Product Change Notice (PCN)

PCN Number: **PCN-0450884R-01**

Product(s) Affected: **PJ1-023-SMT-TR**

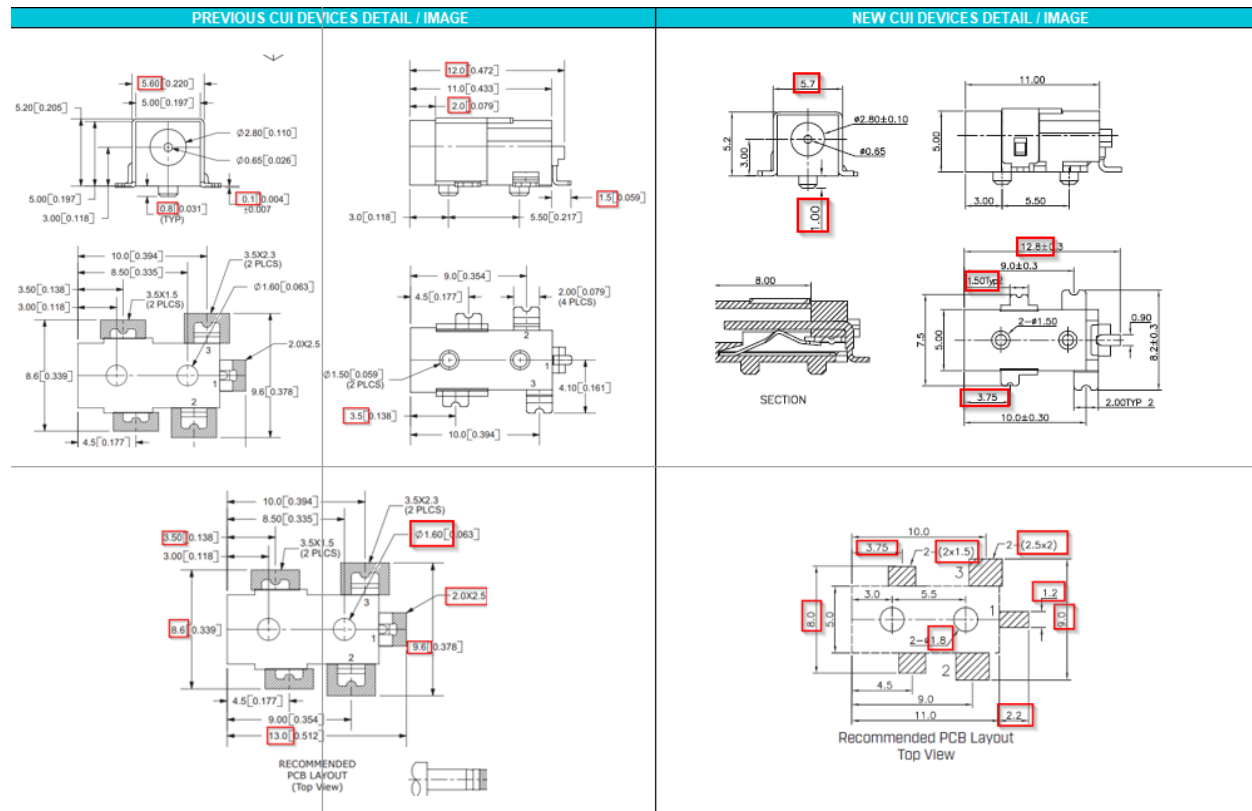
Description of Change: **Minor Housing and footprint differences. Material Change on the housing and terminals. See image Below**

PREVIOUS CUI DEVICES DETAIL / IMAGE			NEW CUI DEVICES DETAIL / IMAGE		
	MATERIAL	PLATING	DESCRIPTION	MATERIAL	PLATING/COLOR
center pin	brass	silver	center pin	brass	silver
terminal 1	brass	silver	terminal 1	brass	silver
terminal 2	copper alloy	silver	terminal 2	SUS301 t=0.25	silver
terminal 3	brass	silver	terminal 3	brass t=0.40	silver
shield	cold rolled steel	nickel	shield	brass t=0.40	silver
plastic	PA6T or equivalent		housing	PA9T (UL94V-0)	black
